INDIANA DEPARTMENT OF TRANSPORTATION

FIRST DRAFT MINUTES

November 15, 2017 Standards Committee Meeting

RE: Minutes from the November 15, 2017 Standards Committee Meeting

601-R-658d (PAGE 8) MIDWEST GUARDRAIL SYSTEM ASSEMBLY LONG-SPAN (REVISED DRAFT)

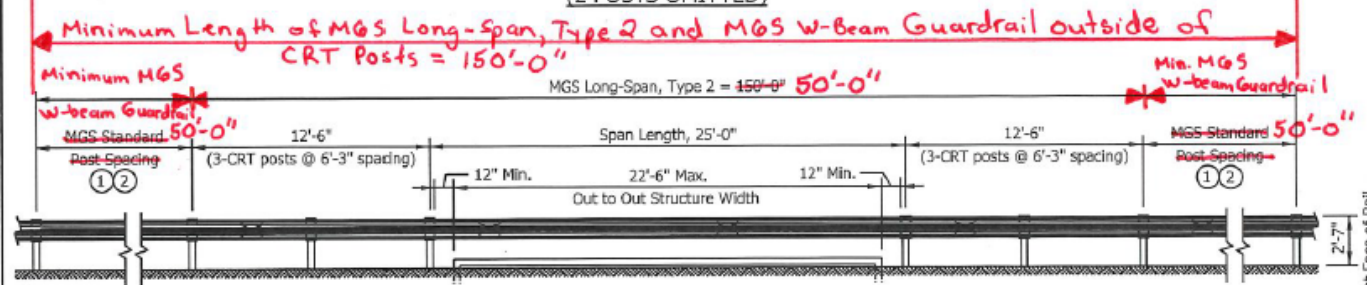
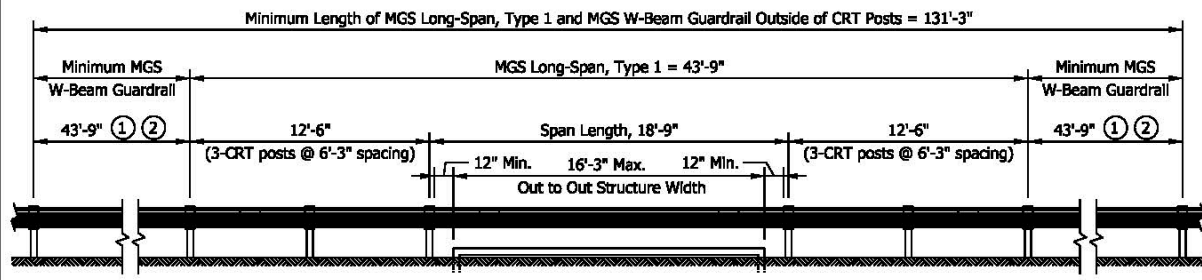
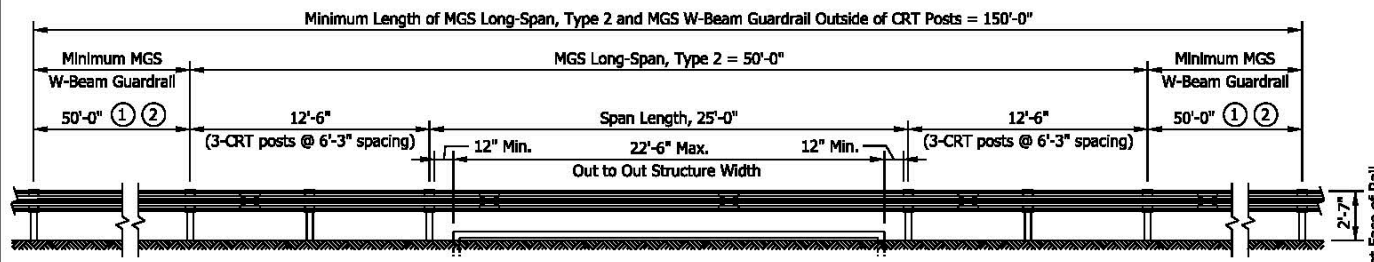
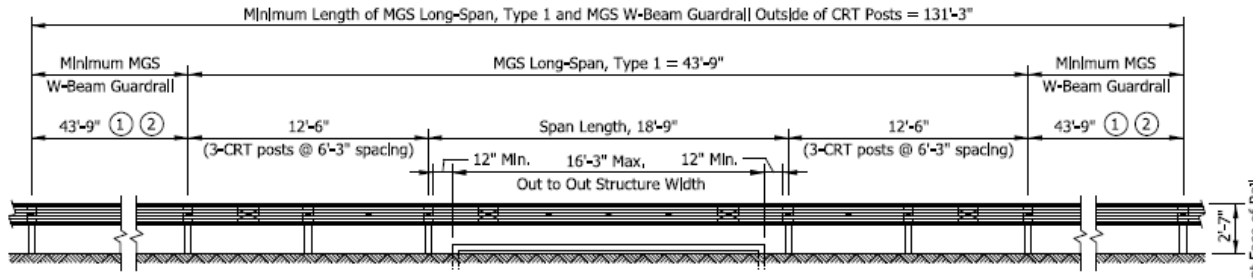
The MGS Long-Span is detailed on sheet 8 of the approved RPD 601-R-658d. The minimum length of MGS w-beam guardrail required upstream and downstream of the outermost CRT post is shown to be included with the MGS Long-Span, Type 1 and Type 2 for both the detail and the pay item. For designer and construction clarity, we believe the pay item for MGS Long-Span should only run between the outermost CRT posts and the minimum length of MGS w-beam guardrail required upstream and downstream of the MGS Long-Span should be paid for separately.

The minimum length of MGS w-beam guardrail required upstream and downstream of the outermost CRT post, may also include a guardrail end treatment, terminal end anchor, or transition. By separating the MGS Long-Span and minimum length of MGS w-beam guardrail into two pay items, it should clarify that guardrail end treatments, terminal end anchors, and transitions are paid for as each, even though they may be included in the minimum length of MGS w-beam guardrail.

PROPOSED SOLUTION: Revise sheet 8 of the approved RPD 601-R-658d by:
Changing the following description, "MGS Standard Post Spacing" to "Minimum MGS w-beam guardrail". The minimum length given on the sheet is not for MGS standard post spacing (6'-3") but for a minimum length of MGS w-beam guardrail which could include a guardrail end treatment, terminal end anchor, transition, or an omitted post in accordance with RPD 601-R-658d sheet 6.

As shown on the proposal sheet, Ms. Smutzer proposes to revise sheet 8 of the approved RPD 601-R-658d by changing the following description, "MGS Standard Post Spacing" to "Minimum MGS w-beam guardrail". The minimum length given on the sheet is not for MGS standard post spacing, 6 ft-3 in., but for a minimum length of MGS w-beam guardrail which could include a guardrail end treatment, terminal end anchor, transition, or an omitted post in accordance with RDP 601-R658d sheet 6.

Further revisions also include revising the limits of the MGS Long-Span, Type 1 and Type 2. Adding dimensions of the minimum length of MGS w-beam guardrail required upstream and downstream of the outermost CRT posts. Editing the last sentence of Note 1 to state, "This length may include the length of a guardrail end treatment, terminal end anchor, or transition." And, removing the reference to the table in Note 1. Ms. Smutzer also proposed to revise the language in Note 1 for clarification and continuity.

Mr. Orton revised his motion and this item passed as revised. Revised draft of the RPD 601-R-658d, sheet 8, is shown in these minutes. Revision to the 601-MGSA-08 will be reflected and will take effect in September, 2018.
